Application for Works Approval

Works Approval Number	W6578/2021/1
Applicant	FQM Australia Nickel Pty Ltd
ACN	135 761 465
File number	DER2021/000358
Premises	Ravensthorpe Nickel Operations Legal description - Part of Mining Tenements M74/175, M74/115 and M74/116 JERDACUTTUP WA 6346 As defined by the premises maps attached to the issued works approval
Date of report	25 October 2021
Decision	Works approval granted

Figure 2: Groundwater monitoring and recovery bores surrounding TSF2

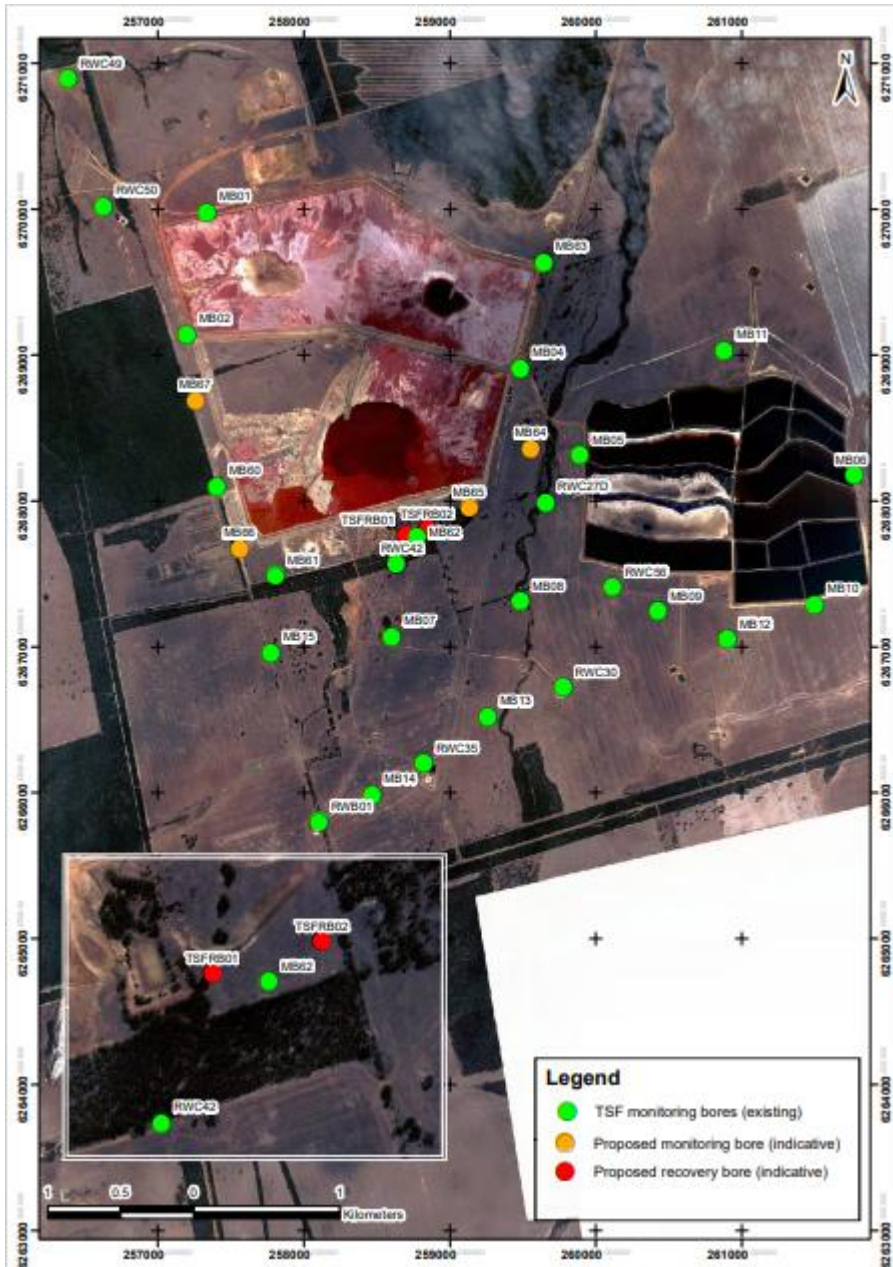
- Installation of a Seepage Collection System that includes an interception/collection trench along the southern flank of TSF2 with recovery decant; and
- Installation of four new monitoring bores (MB64, MB65, MB66 and MB67) and two recovery bores (TSFRB01 and TSFRB02) as shown in Figure 2.

The locations of the proposed recovery bores have been positioned to the south of TSF2 where existing TSF monitoring bores are showing an increasing trend in SWL's. The installation of the recovery bores will enable management of SWL's which would likely breach 6mbgl SWL in the near future without this additional regulatory control.

The locations of monitoring bores MB67 and MB66 which are located to the west and southwest of TSF2 respectively, have been selected by the Applicant based on Golder's recommendation to consider installation of additional monitoring points to the west of TSF2 to capture changes in groundwater levels and chemistry. In order to address the potential

migration of the relatively high levels of magnesium sulphate in MB04, the Applicant has positioned MB64 downstream. The positioning of MB65 is to monitor seepage from the south eastern corner of TSF2 and well as to aid in monitoring drawdown effects in the recovery bores.
